Bureau of Environmental Health

RE: Waiver Approval
4999 Morning Star Drive
Dayton, MD 21036

This letter is being issued in response to your waiver request dated July 3, 2019. Your request for a waiver of the Howard County Code requirement for a percolation certification plan has been **approved**. The proposed thirty (30) by thirty (30) foot garage without plumbing is ten (10) feet from the area established by testing performed in 1973. Health Department records of the testing indicate that there are suitable soils for future on-site sewage disposal system repair that are outside the footprint of the proposed garage. Any deviations from the proposed work illustrated on the site plan submitted with the waiver request will be subject to further review by this department.

4999
Lot 13
45,012 Sq. Ft.
Linden Chapel Hills
Section 3 Fifth District

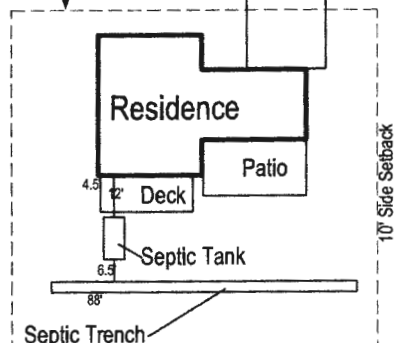
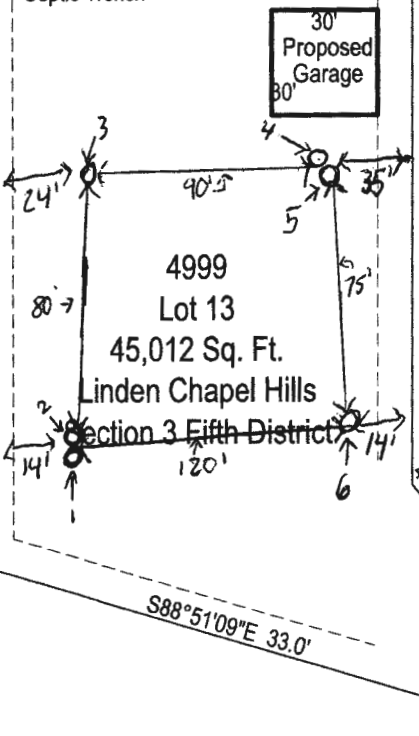
I determined that the best location for the garage would be on the right side of the house, if you were facing the street. The garage will be 10' away from my septic tank but with the drainage field being 88' long, my contractor told me this would be an issue for me. Your sanitarian Hank Oswald suggested that I request a waiver to the percolation test and perc certification requirements. The previous homeowner, on the same side as my perspective garage, added on a patio to the property a few years back without having to re perc the property and I am hoping for the same outcome. This will help save me time and a lot of money.

It looks like the waiver request might be approved, but I need to ask if your planning on paving a driveway up to the proposed garage? If so, then we will need to verify that the pipe in the trench within the area is scheduled 40 PVC.

4999
Lot 13
45,012 Sq. Ft.
Linden Chapel Hills
Section 3 Fifth District

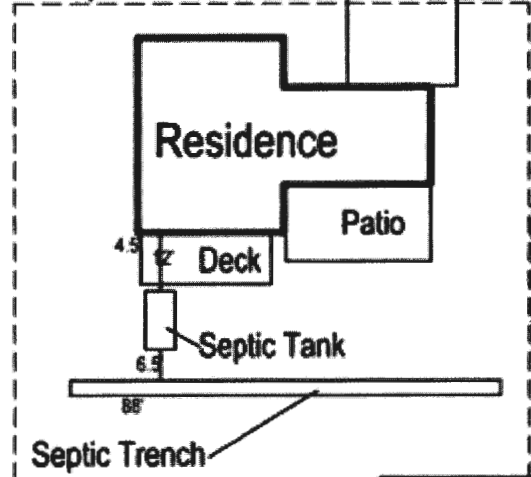
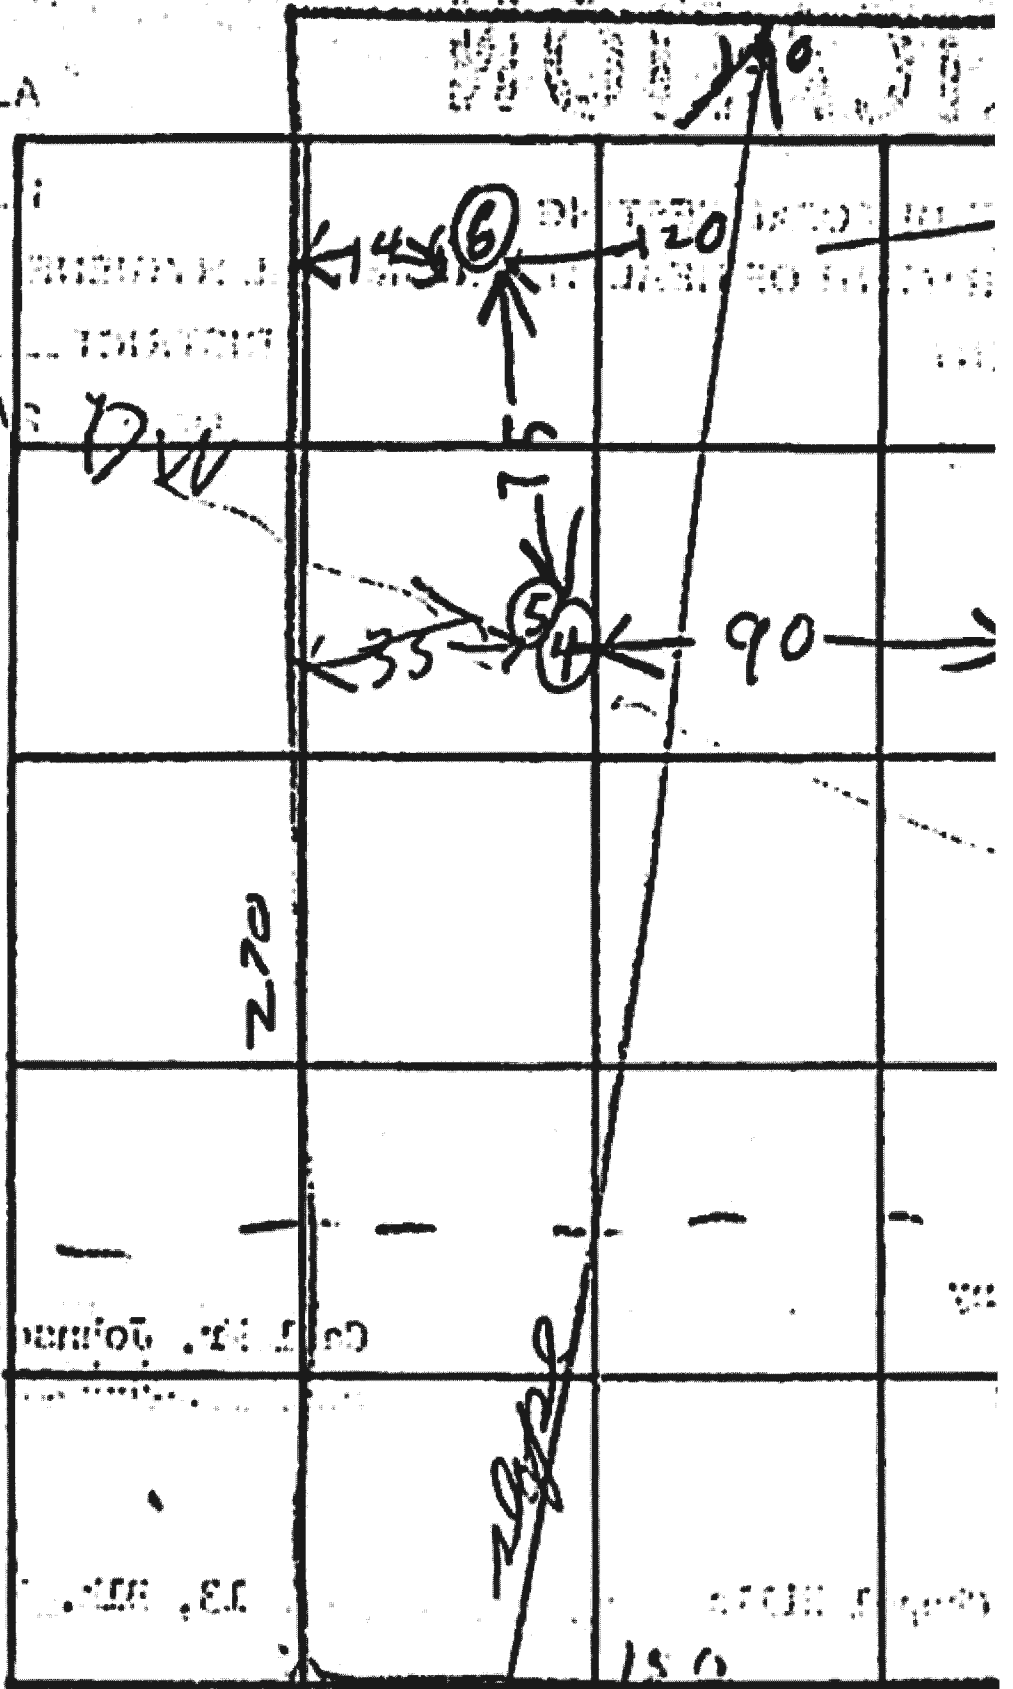
Where is this in reference to my trench.

I am trying to construct a drawing that includes the perc test.

Hole ½ look to be just 20 feet off the rear property line.

It looks like the perc tests were conducted in the far rear of the property.
